MEMORANDUM

RE: N29 WillowWood Residential Phase I (Z-22-00583, SUP-22-00584 and SE-22-00585)

Zoning Map Amendment (Z-22-00583)
Special Use Permit (SU-22-00584)
Special Exception (SE-22-00585)

WORK SESSION DATE

Figure 5: General Development Plan

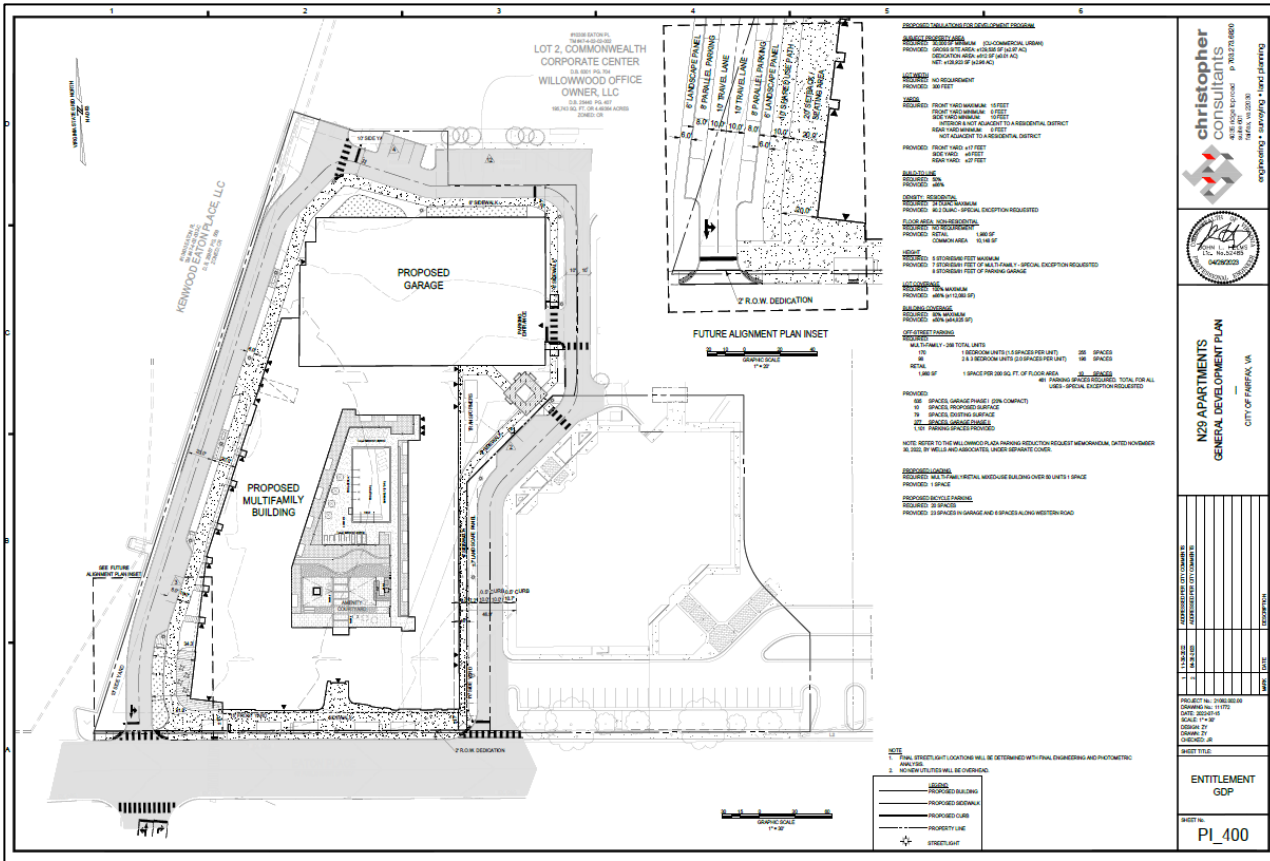
Additional information is required on the general development plan to help staff evaluate how parking is allocated between residential units and commercial uses. The applicant should identify those spaces on the plan. Staff also recommended that the applicant ensure that the parking dimension standards are following Section 4.2.6 of the Zoning Ordinance. The proposed 50 multifamily units in Phase II (10300 Eaton Place) will be parked at two spaces per unit

Building/Fire Code: The plan needs to show the area between the private roadway and the edge of the building being reinforced to handle the load imposed by the outriggers of Tower Ladder 403. The plans also need to show two (2) Fire Department Connections (FDC) located remotely on the residential building, and two (2) FDCs located remotely on the parking deck. The current design indicates the parking deck has an independent manual dry standpipe system. A fire hydrant must be located within 50 feet of all fire department connections. The use of existing fire hydrants spaced greater than 50 feet should be indicated on the plans for consideration. The applicant will need to submit all turning movements using the correct specifications for the City of Fairfax Tower Ladder 403. Finally, the private roadway will be designated a Fire Lane in its entirety. The required marking specifications are not included in the plans. Continuous curb and surface painting (both sides) and signs must be shown on the plans.

Public Works/Transportation: The internal roads shown at 20' (curb to curb) are too narrow. Truck turning movements do not work with two-way traffic, even with a smaller truck (WB-30). Also, regular access to the loading space should not require multiple maneuvers. The applicant should ensure that safety issues (i.e., sight distance) are addressed and the location of on-street parking abutting the shared use path along the western road is not ideal. Likewise, building doors opening into the path of bicyclists and pedestrians, and car passenger doors opening may also present conflicts for the applicant to reconsider. The Traffic Impact Study is under review. The proposed Transportation Demand Management has been reviewed and staff has provided comments to the applicant.

Figure 6: Stormwater Management Plan

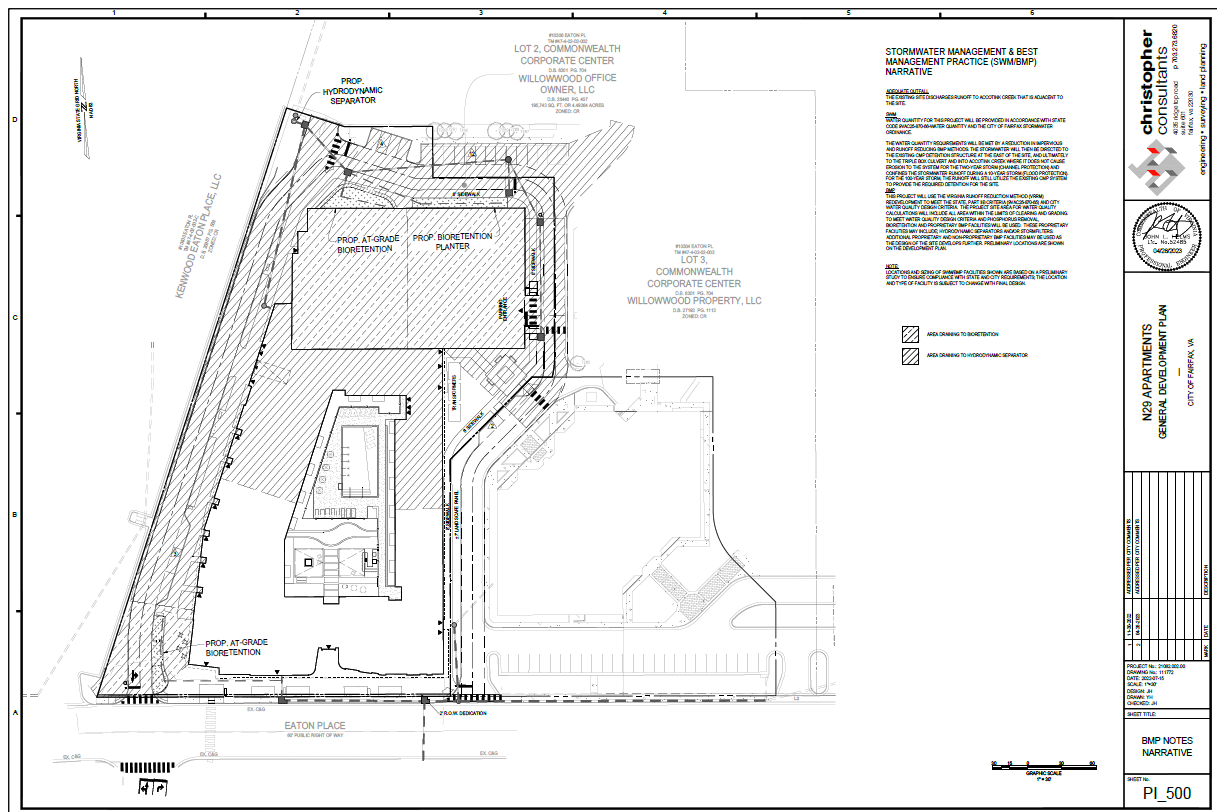
Public Works/Civil: The applicant needs to clarify whether the water quality requirements will be met on-site and as part of this phase of development.
